Re: Florida Power & Light Company  
Proposed Turkey Point Units 6 and 7  
Docket Nos. 52-040 and 52-041  
Response to NRC Request for Additional Information Letter No. 081 (eRAI 7804)  
SRP Section 02.05.01 – Basic Geologic and Seismic Information

Attachment: FPL Response to NRC RAI No. 02.05.01-34 (eRAI 7804)

**NRC RAI Letter No. PTN-RAI-LTR-081**

**NRC RAI Number: 02.05.01-34 (eRAI 7804)**

**Figure 1.** Kula's (Reference 1) Figure 4-6 location map of deep-rooted faults mapped showing, from west to east, Faults A (yellow), B (blue), C (Green), and D (Purple). Kula only considered Faults A and B to be active

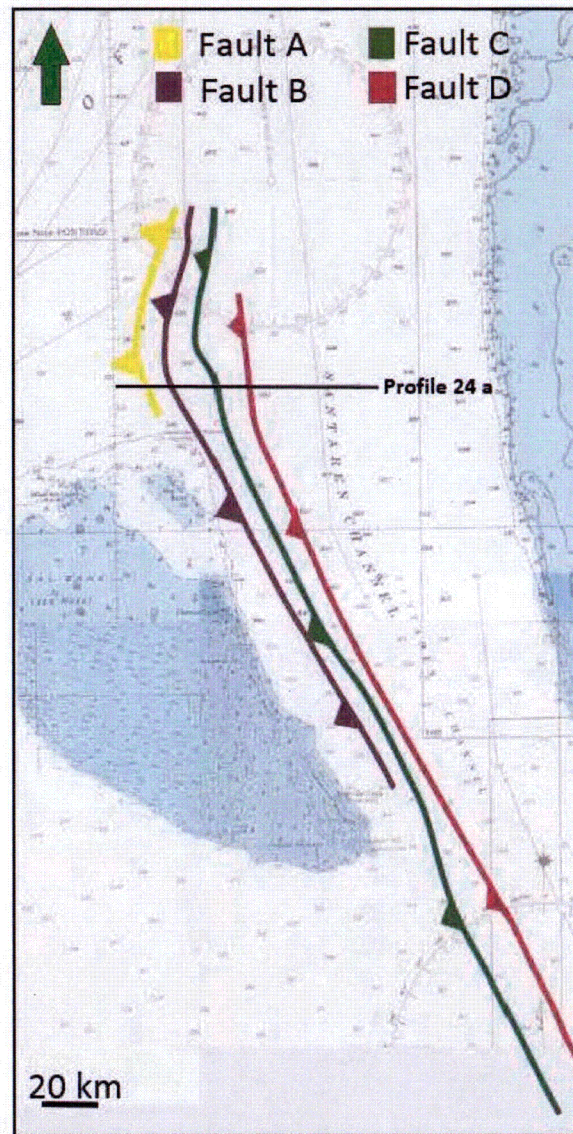
Kula (Reference 1) divides the deep-rooted tectonic faults into two subgroups, including: (1) steeply dipping wrench faults, which include Faults A and B; and (2) thrust fault systems, which include Faults C and D (Figures 1 and 3). Kula suggests these faults range in length from 41 km (Fault A) to 180 km (Fault C), as illustrated on Figure 1. The interpreted fault lengths, vertical offsets, and activity of these faults are presented in Table 1. Only Faults A and B, the shorter faults directly east and north of Cay Sal Bank,

**Figure 3.** Kula's (Reference 1) Figure 5-3 showing interpreted Profile 20, mapped horizons, and Faults A through D. Note seafloor break above Fault A and fluid escape acoustic pipe near western end of profile, and the Cay Sal anticline between Faults A and B. Profile location shown on Figure 12.

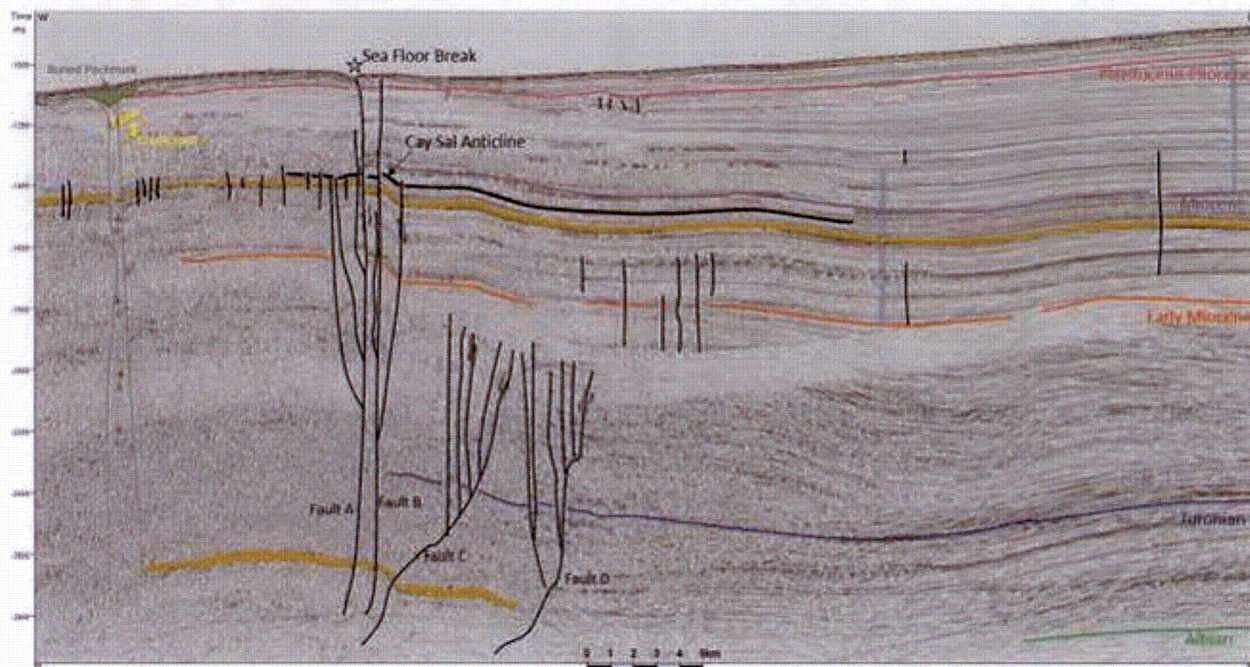
Kula (Reference 1) cites seafloor breaks as evidence for neotectonic activity, and notes such breaks on seismic profiles (Figures 3 and 6) as well as multibeam bathymetry (MBES) data (Figures 7a and 7b). On Profile 20 (Figure 3), Kula suggests the break zone is about 1 km wide and 15 m deep. Profile 24A (Figure 6) is located along the northeast margin of Cay Sal Bank. On this line, Kula suggests that Fault A offsets the seafloor by about 50 m. Overall, the seafloor break is meandering and circuitous in map view, extending for about 40 km (Figures 7a and 7b), and is up to 1 km wide (Kula, 2014) (Reference 1).

As previously stated, Prof. Eberli considers only one feature to be active. This is the fault-cored fold of the Cay Sal anticline apparent on Profile 20 (Figure 3). Prof. Eberli interprets this structure as a wrench fault system with components of both local compression and strike slip motion, and suggests it may be the far field expression of a lateral stress component along the American-Caribbean plate boundary. Prof. Eberli notes that the offset of seismic reflections along the fault is very small, indicating that no major vertical movement is associated with this structure. Prof. Eberli stated that the only other defensible technical explanation for the observed folding and faulting on Line 20 may be the compaction and subsidence difference along the buried platform margin along which fluid escape occurs, and suggests that this is not a likely seismic source.

**Figure 4.** Idealized cross Section X-X' Across Cay Sal Bank (Kula, 2014, Figure 5-18 [Reference 1]).

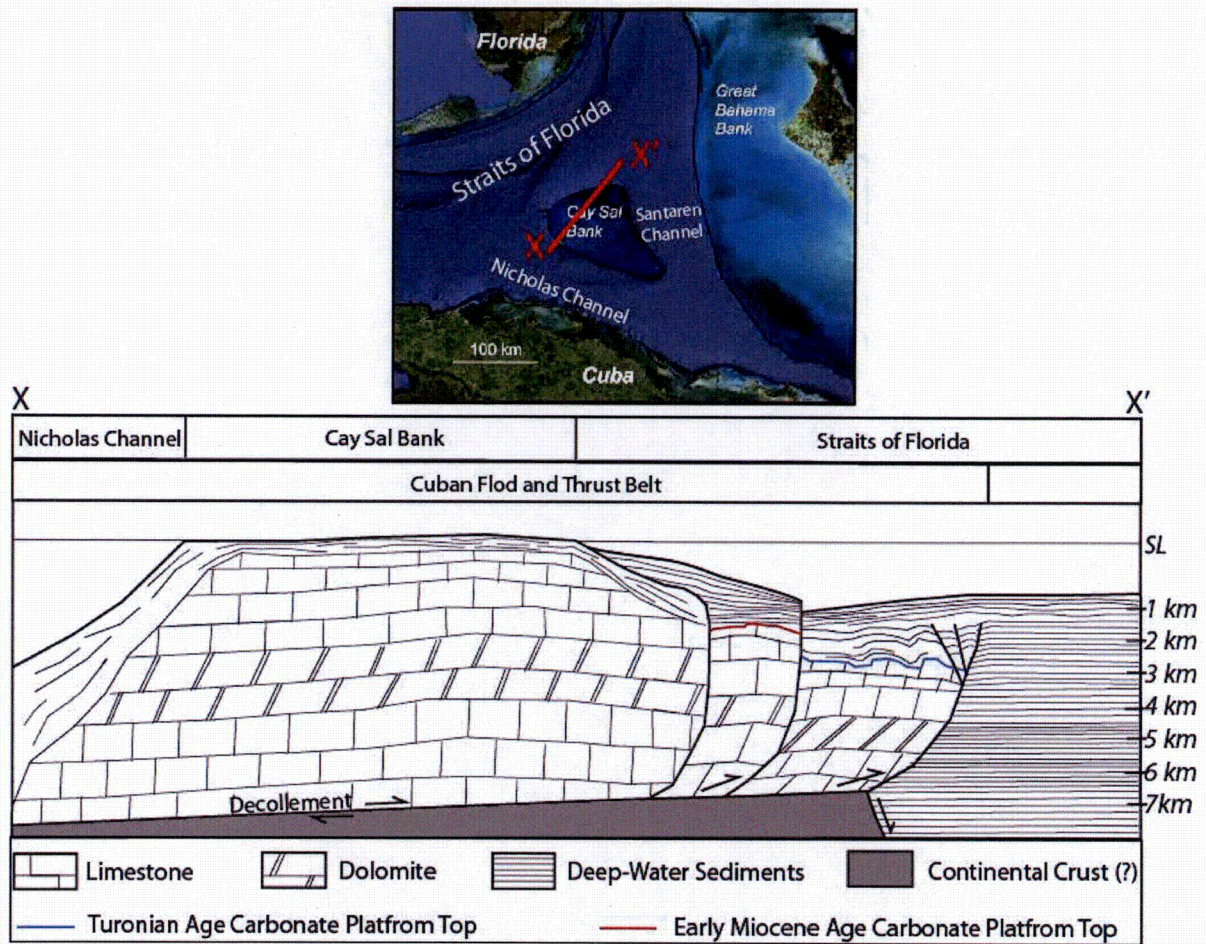
Kula (Reference 1) suggests all four tectonic faults splay off an approximately 8-km-deep detachment horizon (decollement) (Figure 4), and may be related to detachment folding interpreted by Masferro et al. (1999) (FSAR Reference 2.5.1-426) in the southern Santaren Channel. Kula presents a cross section X-X' illustrating >1 km of vertical separation of the top of an early Miocene horizon, as well as older units, across several faults (Figure 4). However, the amount of this vertical separation is not consistent with separation amounts described in the text of Kula's thesis (Table 1). Kula also suggests that tectonic shortening above the detachment is responsible for local folding on the Cay Sal anticline to the northeast.

Kula's (Reference 1) cross section X-X' (Figures 4 and 12), which depicts >1 km of vertical offset of Cretaceous carbonate bank along several faults splaying off a subhorizontal decollement (detachment) crosses the western portion Line BH81-12B\_mig (Figure 16). The mid-Miocene and pre-Cretaceous horizons do not exhibit any vertical separation and are unfaulted at this location. There is no evidence supporting the existence of either a deep detachment or tectonic Faults B, C, and D along this seismic line.

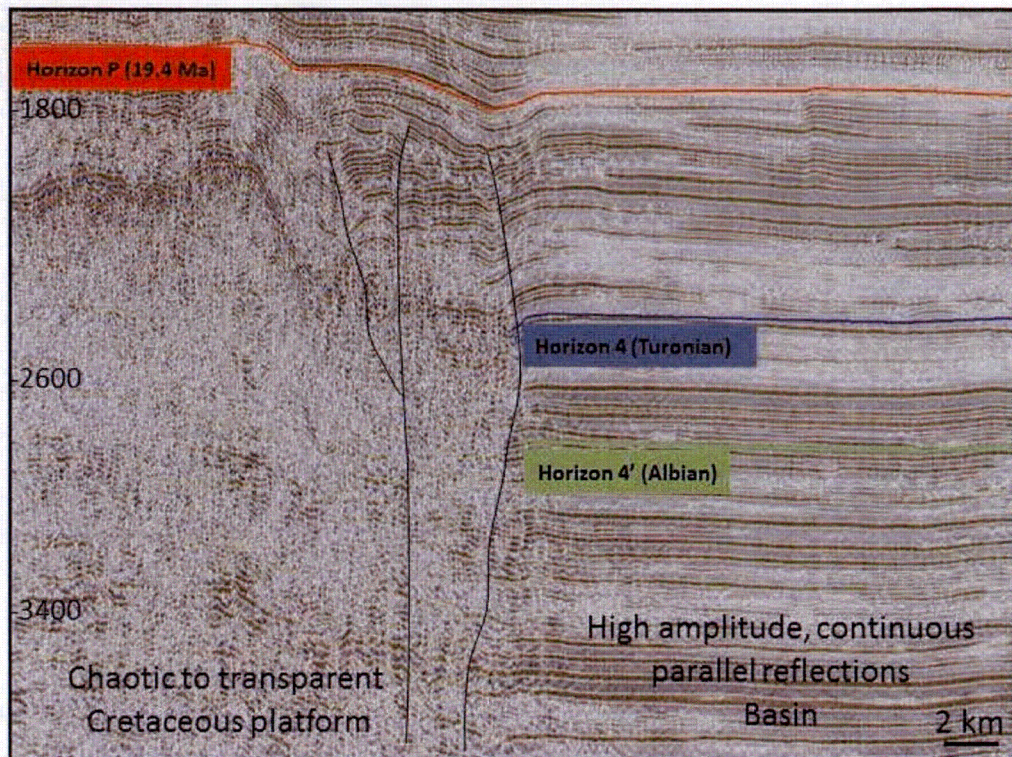
Almost all of the profiles presented by Kula (Reference 1) are limited-penetration data, but Kula presents only one deep-penetration industry seismic profile (GSI Line BH81-34 shown on Figure 5) from northern Cay Sal Bank. On this profile, Kula maps pre-early Miocene faults near the margin of a buried carbonate platform margin. Kula suggests that drowning of the platform occurred in the early Miocene, and that low amplitude reflections observed in the buried platform facies likely result from differences in acoustic impedance resulting from alternating limestones and dolomites in the Lower Cretaceous, and evaporates in the Upper Cretaceous (Eberli et al., 2004) (Reference 2). Kula interprets high-amplitude, parallel, semi-continuous seismic reflections within the carbonate bank deposits to represent carbonate-anhydrite alterations. The faults mapped by Kula on GSI Line BH81-34 exhibit very little (less than 15 m) vertical separation of seismic reflections, and are shown to terminate well below a horizon mapped as 19.4 million years old (early Miocene). These faults may correspond with Kula's Faults C and D (Figure 1 and Table 1), but are not labeled as such on Figure 4-6 in Kula (Reference 1) (Figure 5).

**Figure 10.** Enlarged version of Kula's (Reference 1) Figure 5-3 showing interpreted seismic Line 20. Line location shown on Figure 12

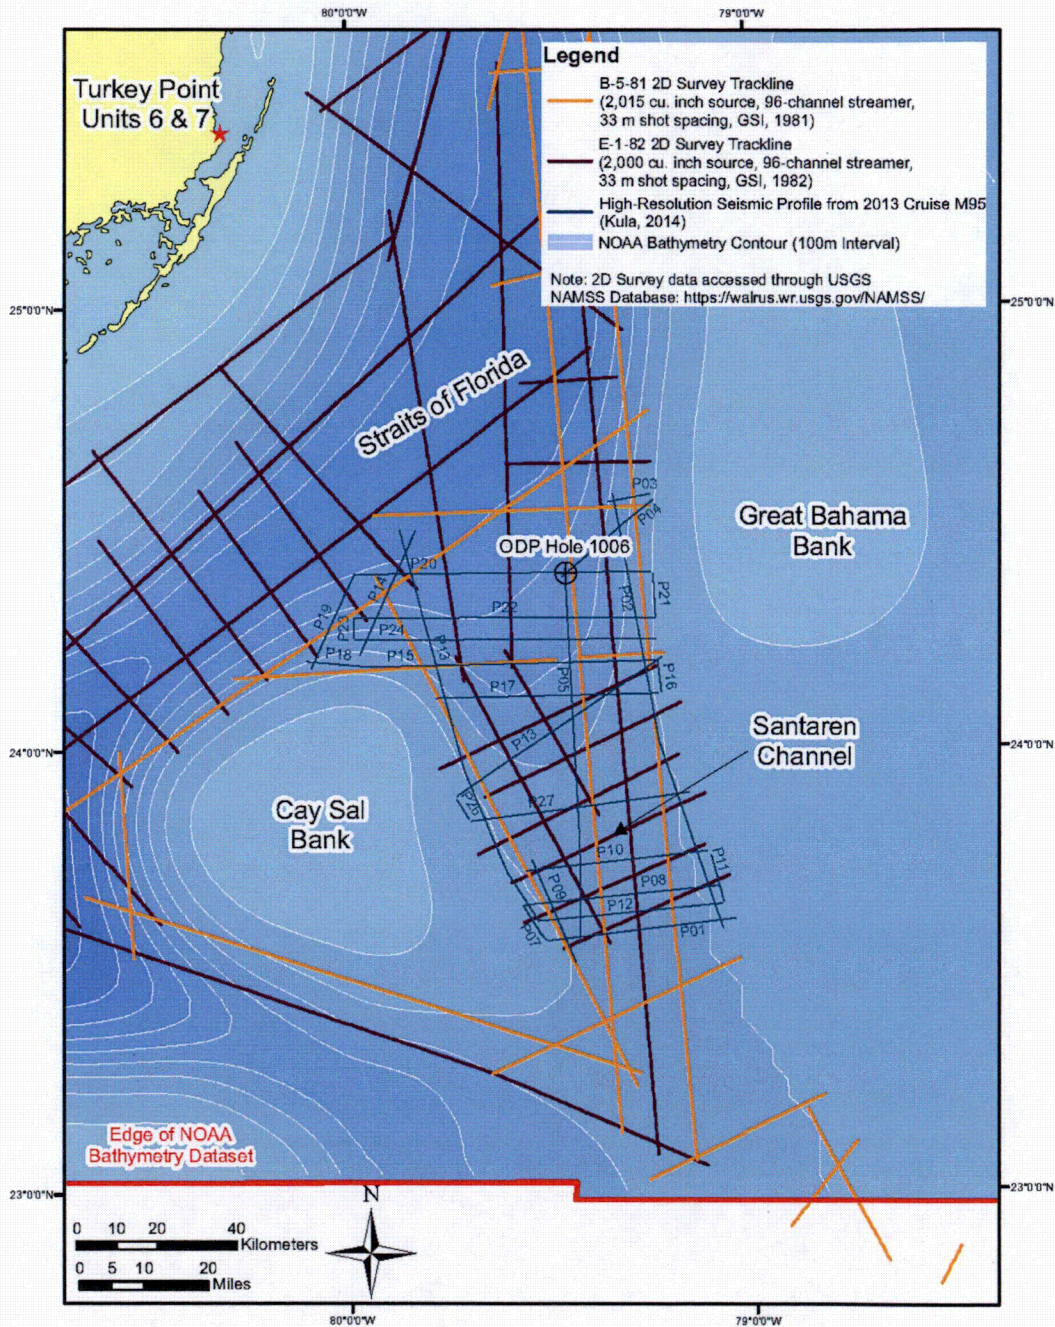
M95 Profile 20 provided by Prof. Eberli. This is a higher resolution image of the same line presented by Kula (Figure 3), and intersects GSI Line BH81-34 also interpreted by Kula (Figure 5). One of the mapped faults (Fault A) in this image extends to the seafloor. Prof. Eberli interprets this as a minor wrench fault exhibiting both compressional and strike-slip motion, with no observed vertical offset of the Plio-Pleistocene boundary. Minor down-to-the-east normal faulting is apparent on middle Miocene and older strata on this profile.

Prof. Eberli stated in his discussions with the TI Team that within the entire M95 dataset, this feature (faulted Cay Sal anticline, Figures 3, 8, and 10) represents the only active tectonic structure. A re-interpretation of M95 Line 24 by Prof. Eberli is shown on Figure 11. The seafloor break on this line is interpreted by Prof. Eberli as the headscarp on a MTC that formed approximately 1.8 Myrs ago. The subsurface seismic data (Figure 11) and geomorphic expression (Figures 7a and 7b) of this MTC are similar to features described by Mulder et al. (2012) (FSAR Reference 2.5.1-984) and Tournador et al. (2015) (Reference 3) for other MTC complexes in the region. Prof. Eberli does not map a fault beneath the feature, as suggested by Kula (Figure 6). Unfaulted seismic reflections of Pliocene age underlie the MTC headscarp, providing evidence of no deeper faulting at this location.

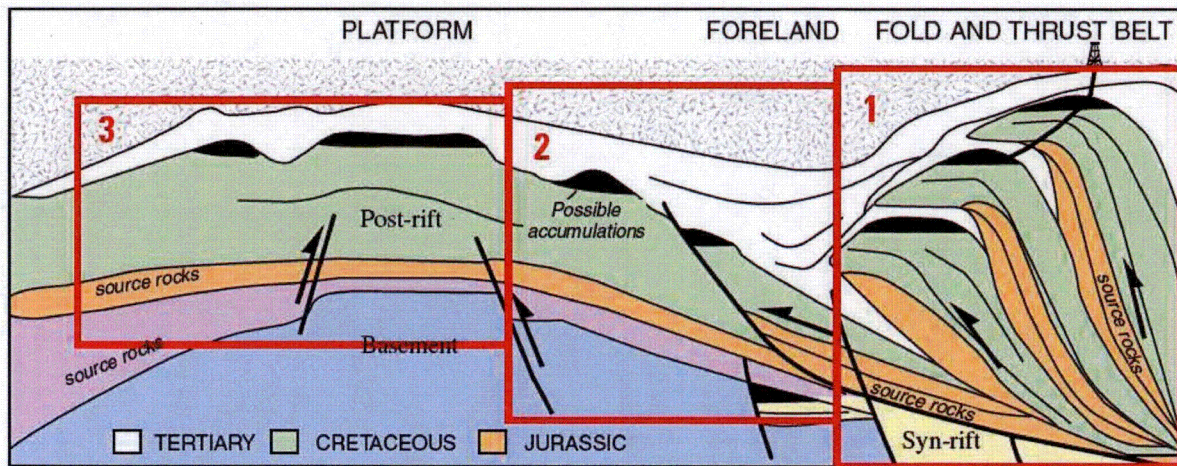
Kula (Reference 1) proposes a modification to Schenk's (2008; 2010) (References 9 and 10) boundary of the Cuba Fold and Thrust Belt by incorporating the Cay Sal Bank in the Cuba fold and thrust belt (Figure 22). In the Kula modification of this boundary, the Cuba Fold and Thrust Belt and North Cuba Platform Margin of Schenk (2010) (Reference 10) remain undifferentiated in the Cay Sal Bank area (Figure 22). Kula's modification, included here as Figure 22, leaves unclear the question of whether Cay Sal Bank should be considered part of the fold and thrust belt or platform margin in
